SITE INSPECTION REPORT

Project: Kingscliff Public School		Contractor: RCC
Date of Inspection: 28/8/23		Start Time: 1pm
Inspection by: Richard Smith		Finish Time: 1:30pm
ACOR Project No: BR200435		Weather: Fine
Inspection Report No: KPS- 42	No. Pages:	Site Manager Name:
Works Inspected: Bulky 4 - Columns in PACT + Lift WALLS		
Drawing Reference:

Kingscliff Public School Building 3 and 4

BUILDING 4 - GROUND FLOOR PLAN PART A

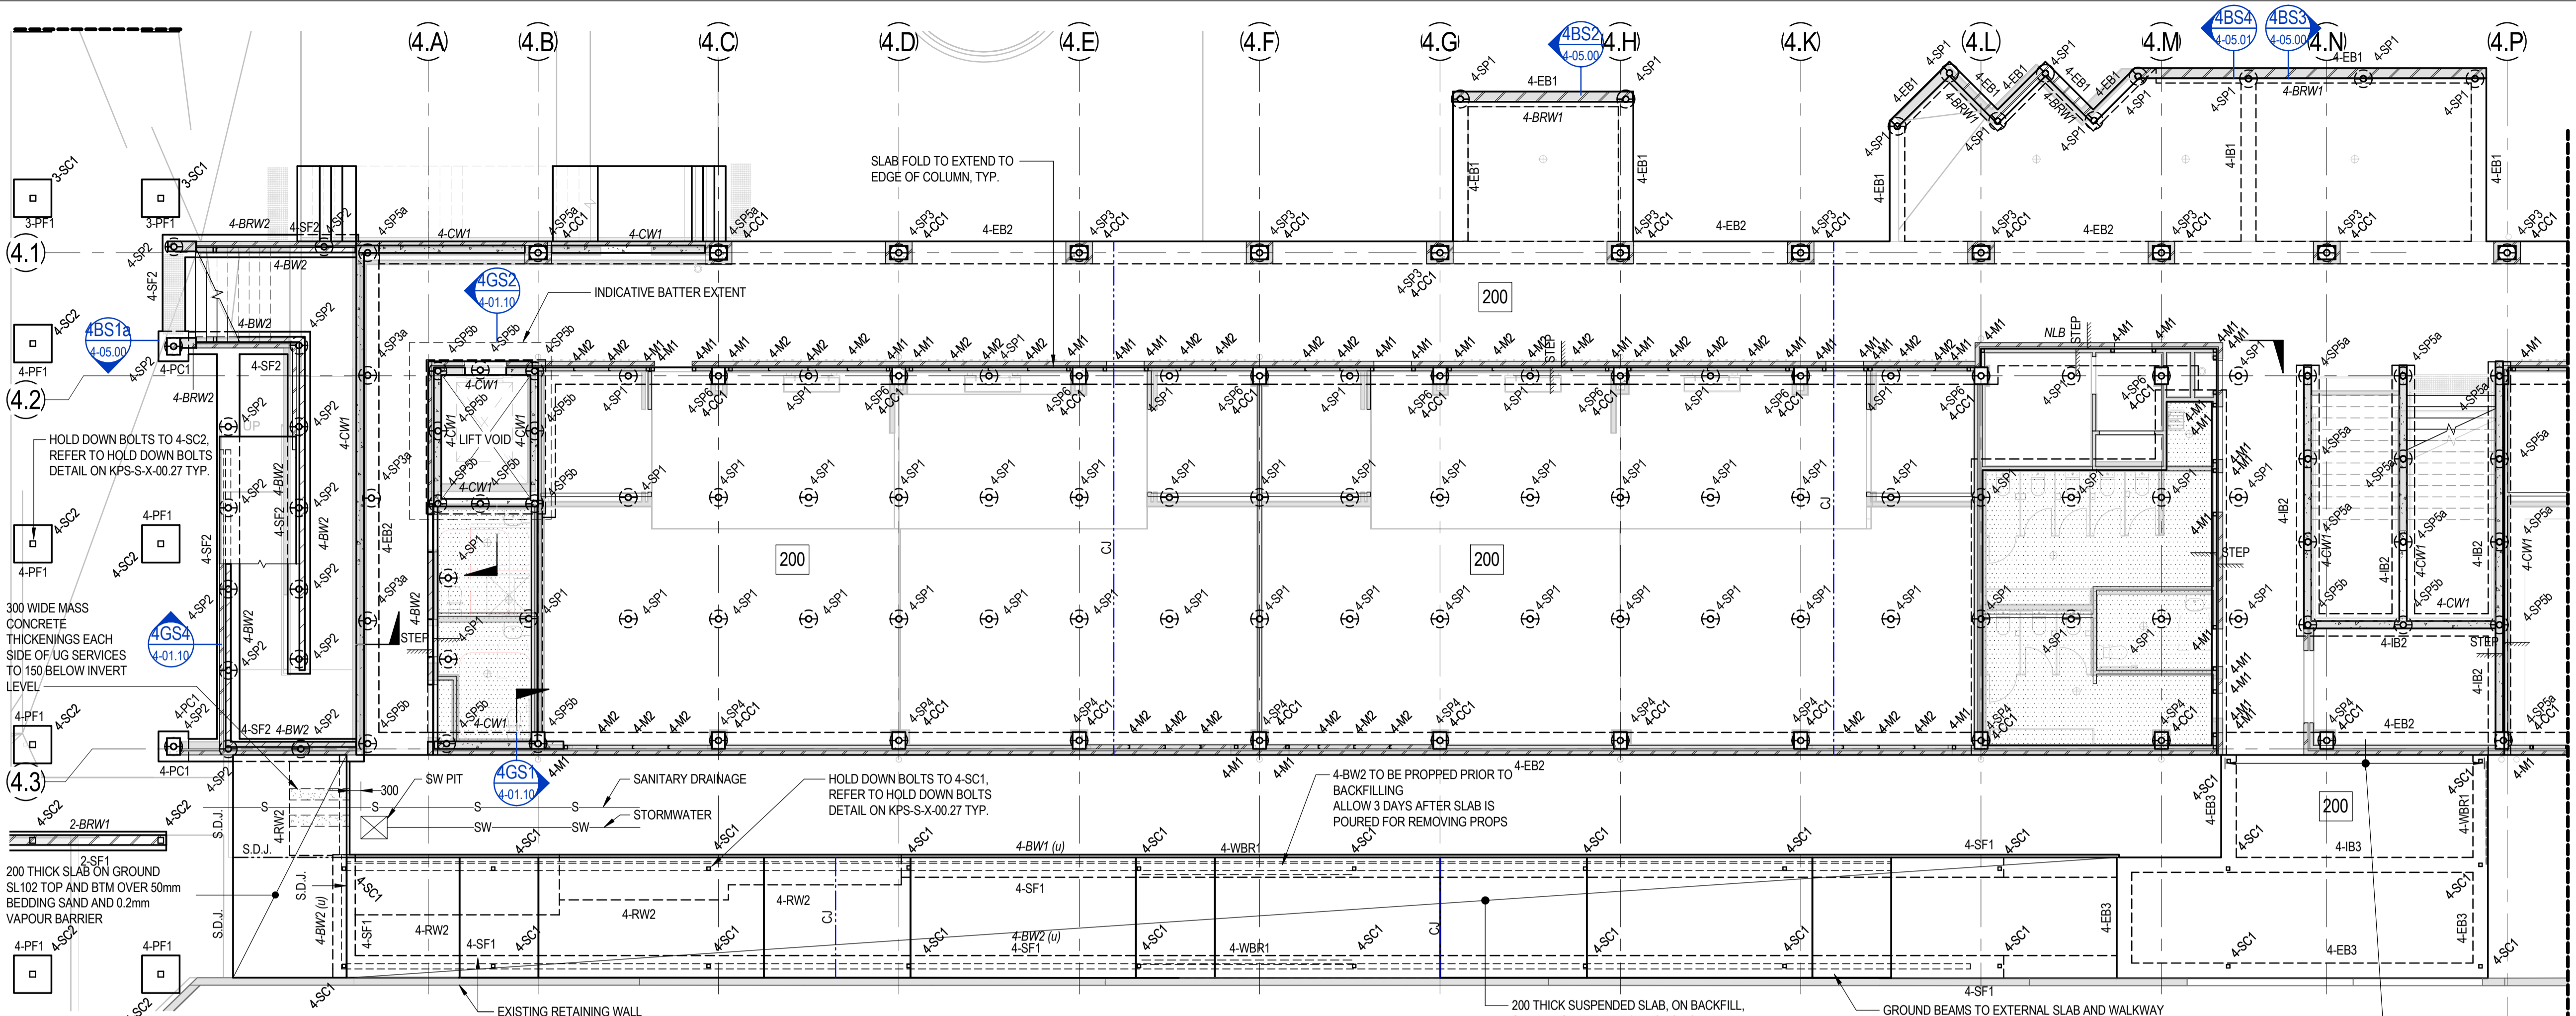
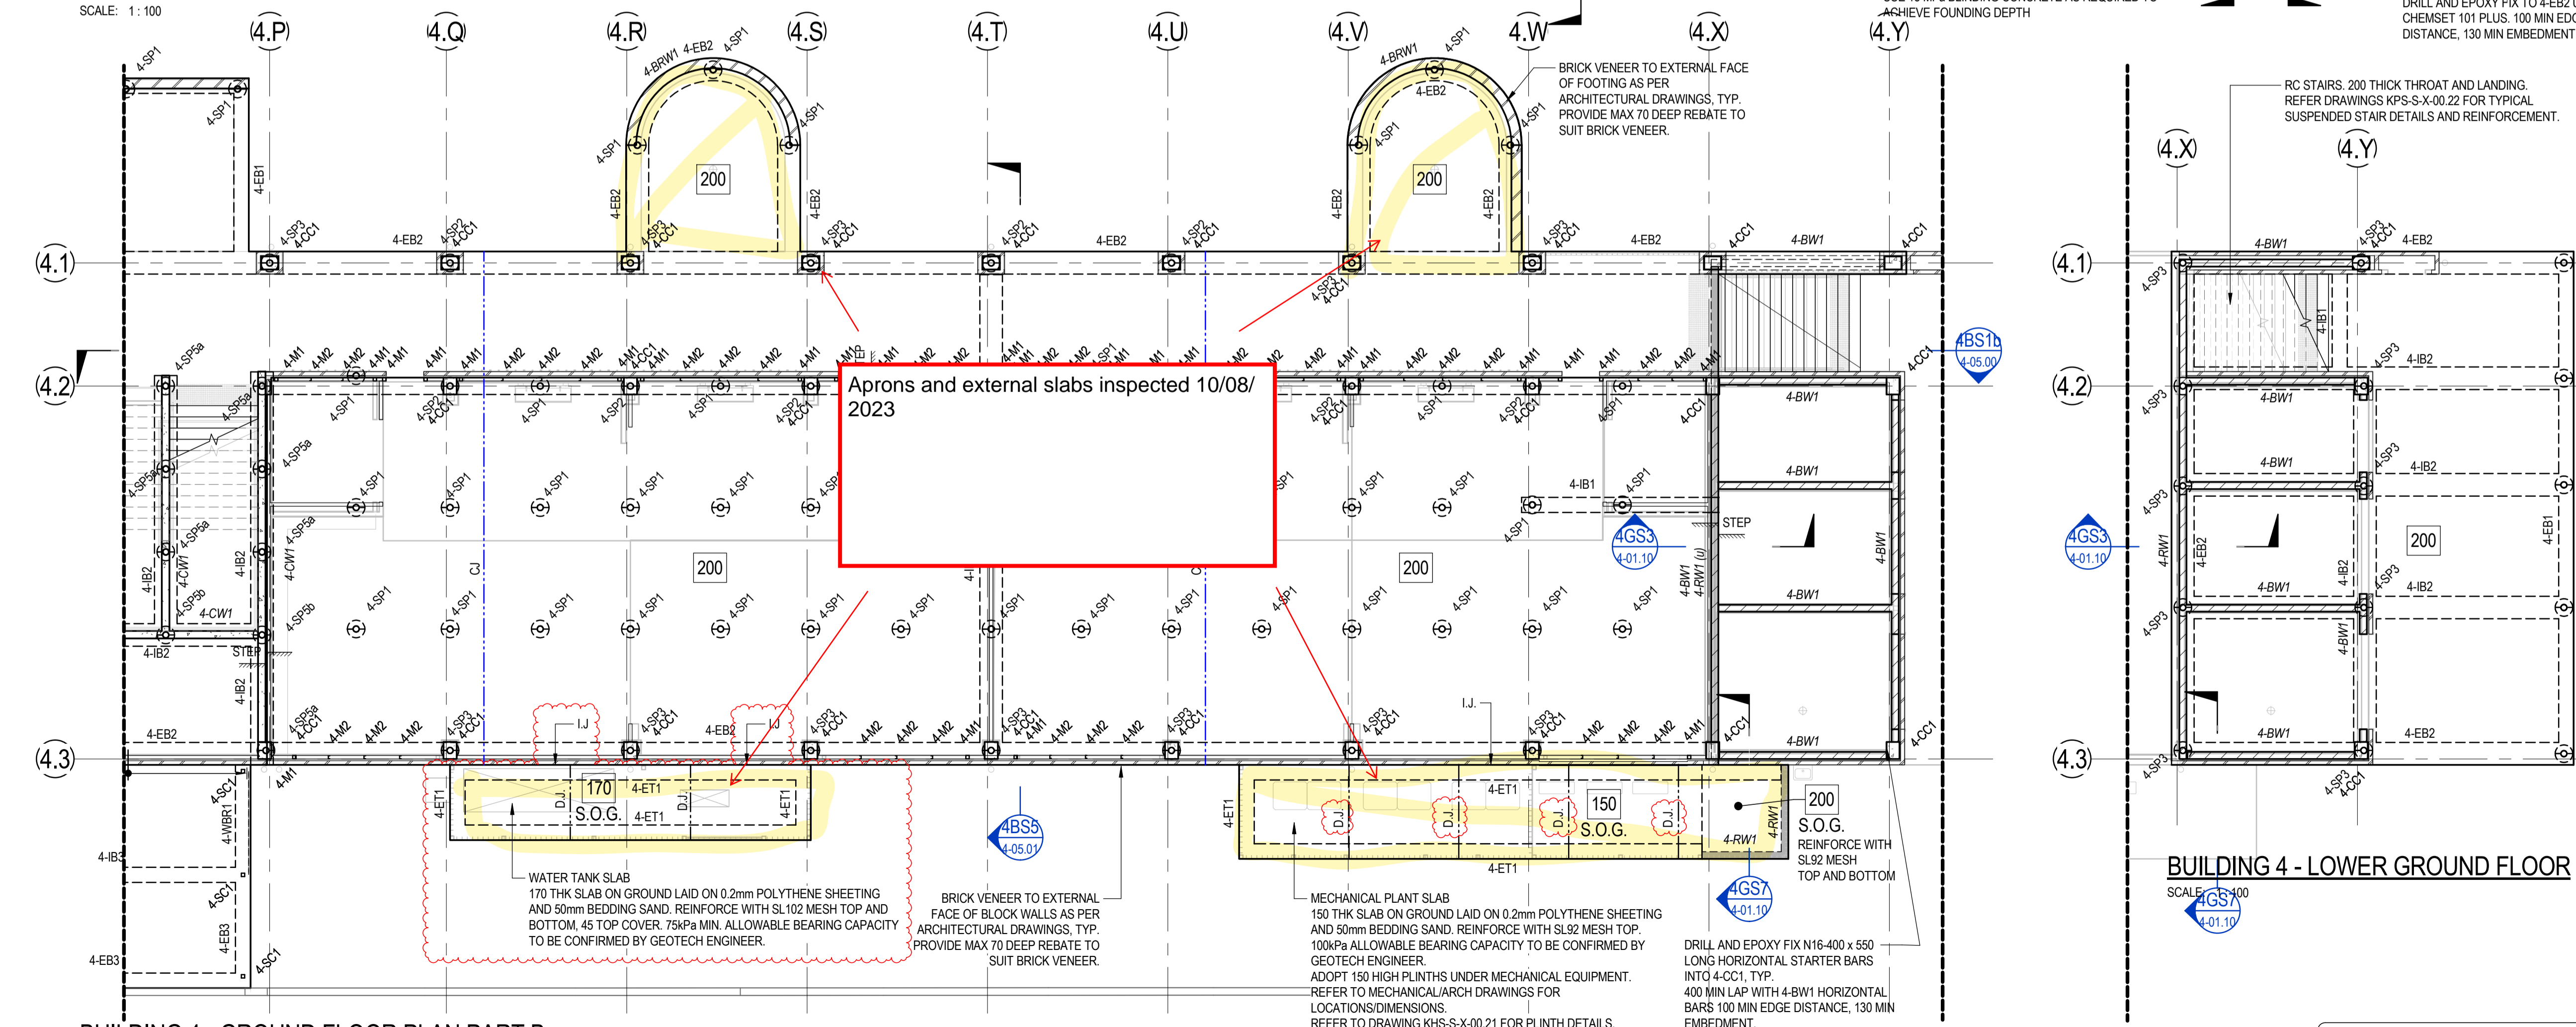
EXTENT. REFER MARK-UP

1.	APRONS
2.	* ADD MESH CHAIRS
3.	* " SHEAR BARS TO SCREW PILES.
4.	
5.	SLABS
6.	* ADD REMAINING DOWELS
7.	
8.	
9.	THEN WHEN ABOVE COMPLETE
10.	OK TO POUR.
11.

BUILDING 4 - GROUND FLOOR PLAN PART A

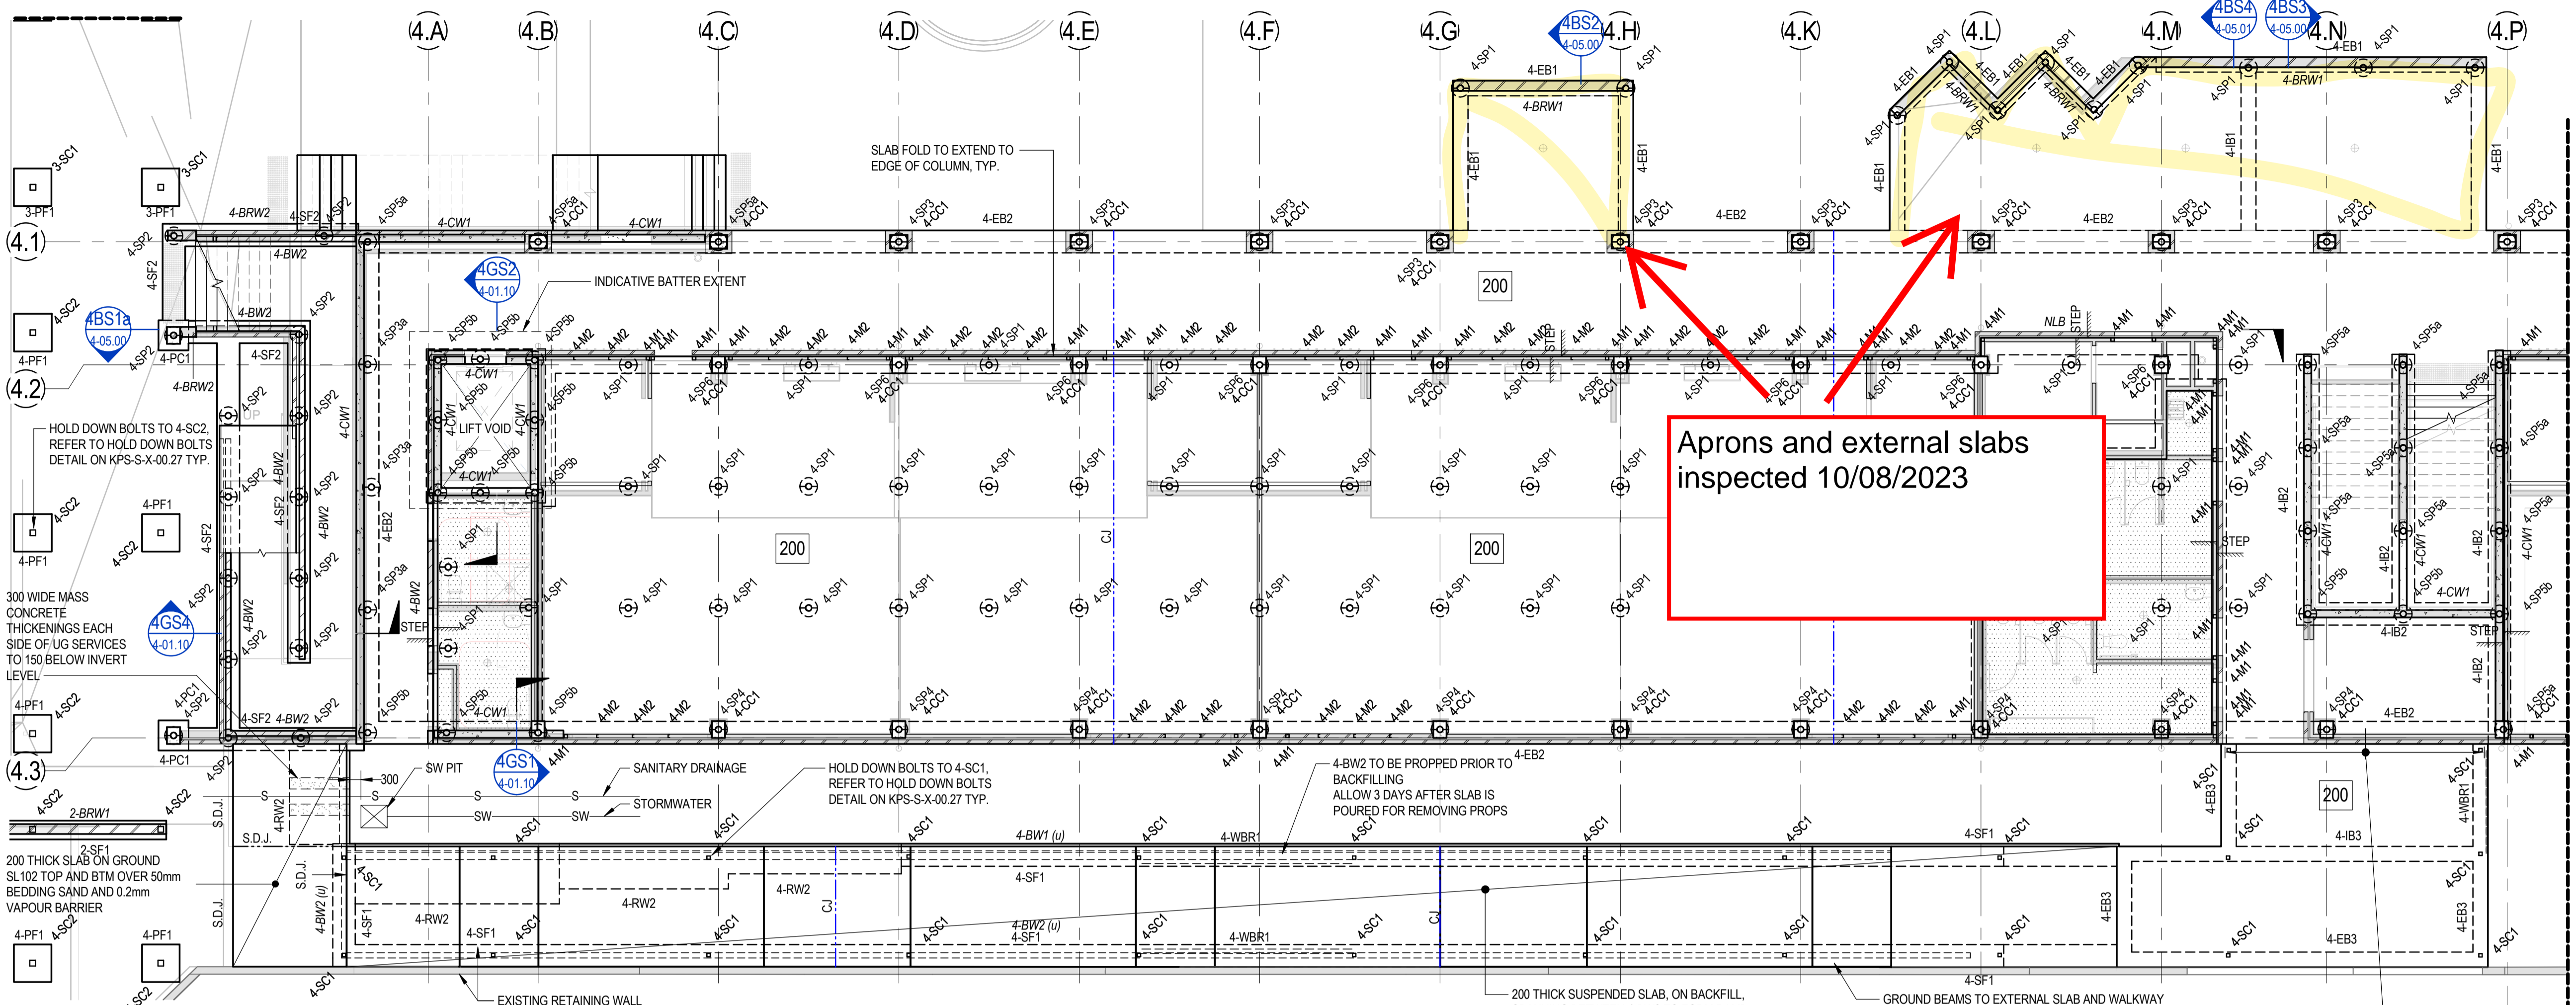
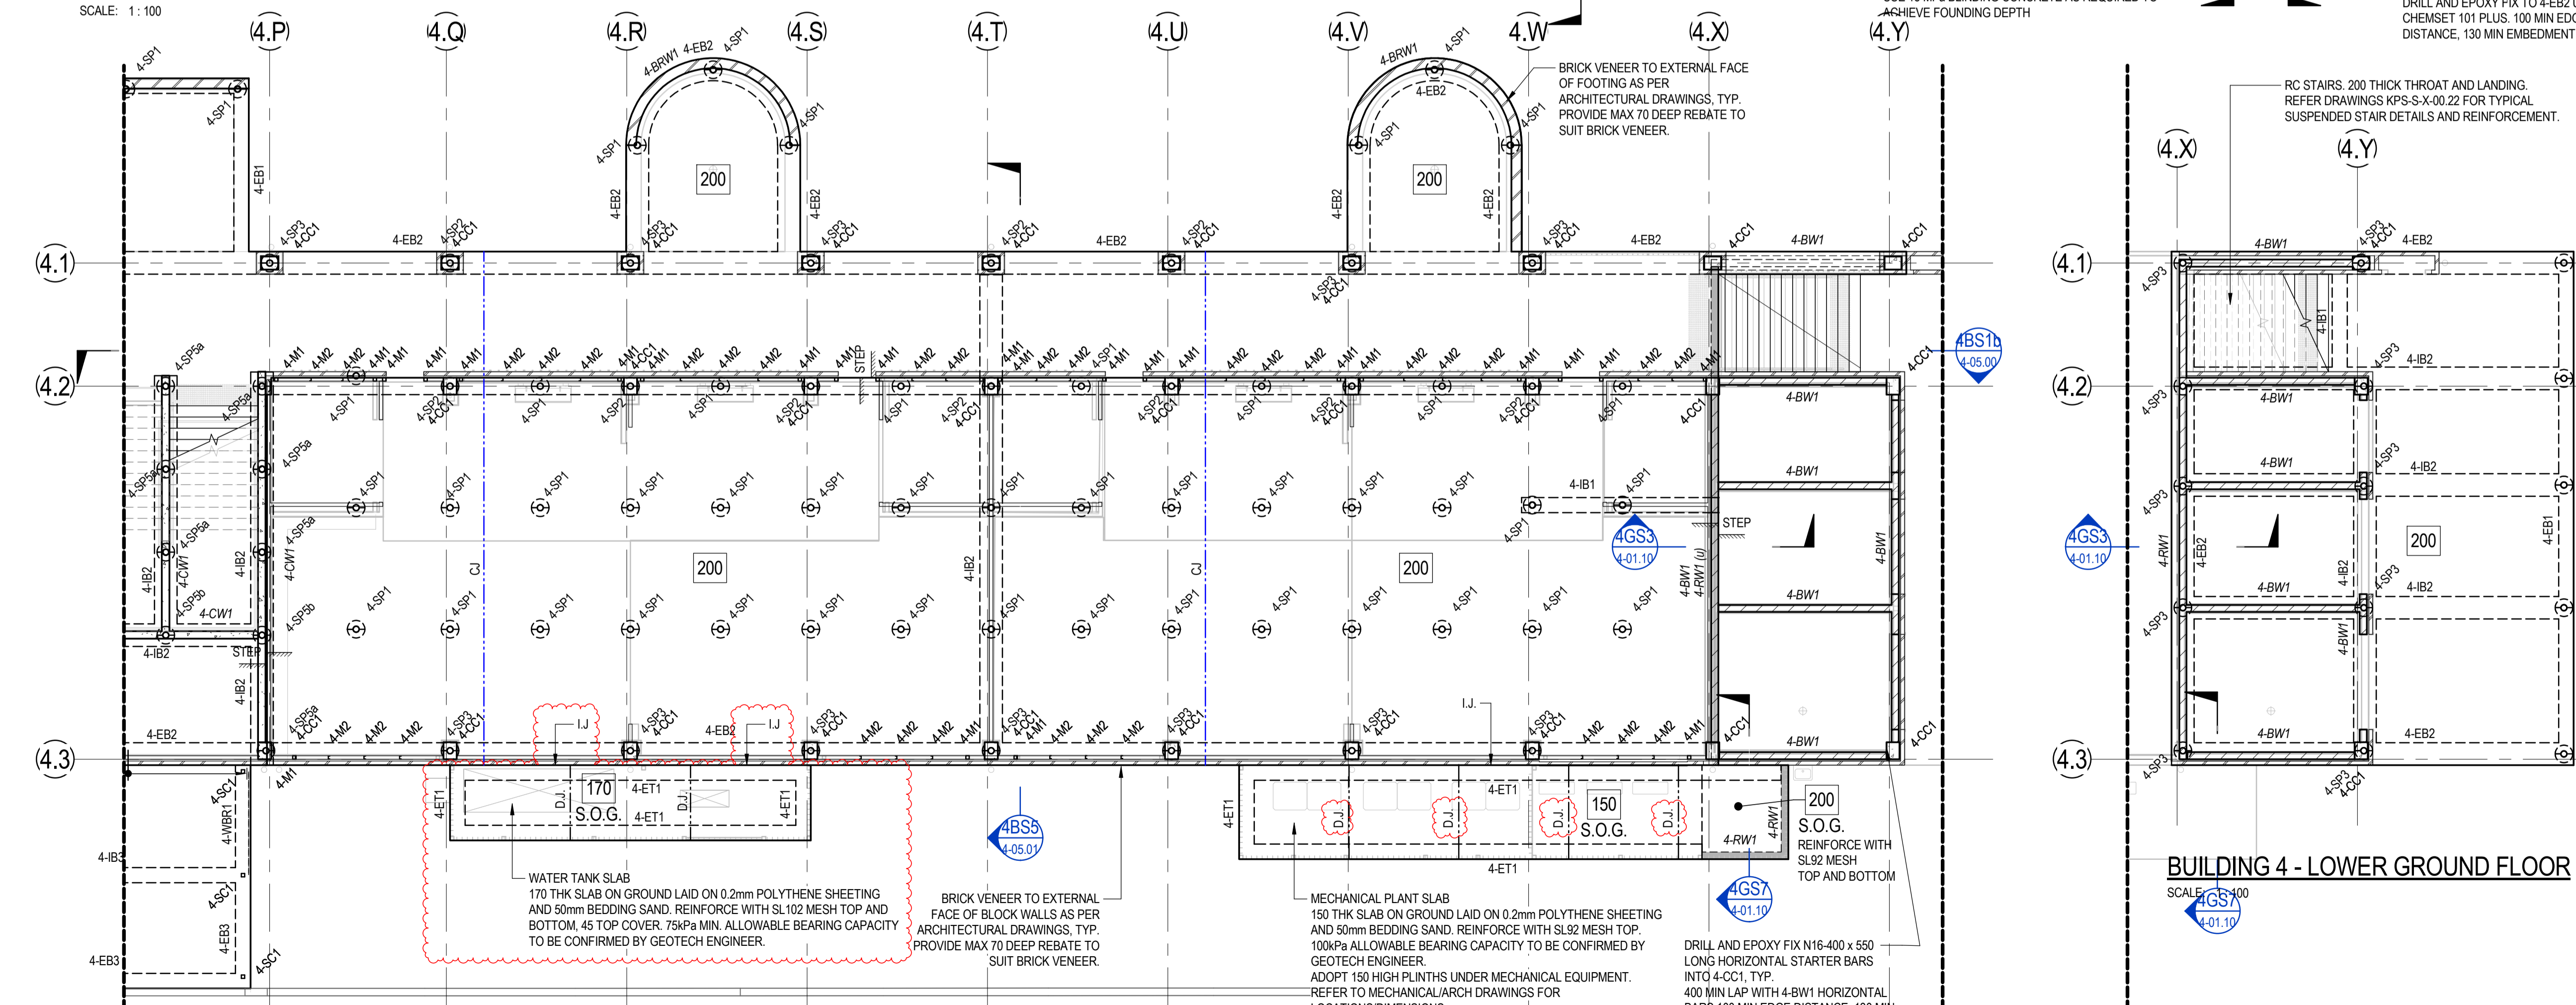
EXIENT REFER ATTACHED MARK-UP

1.
2. * ADD SHEAR BARS
3. * ADD TOP MESH AND CHAIR
4. * ENSURE COLLECT COVER
5.
6. WHEN ABOVE COMPLETE OK TO POUR
7.
8.
9.
10.
11.
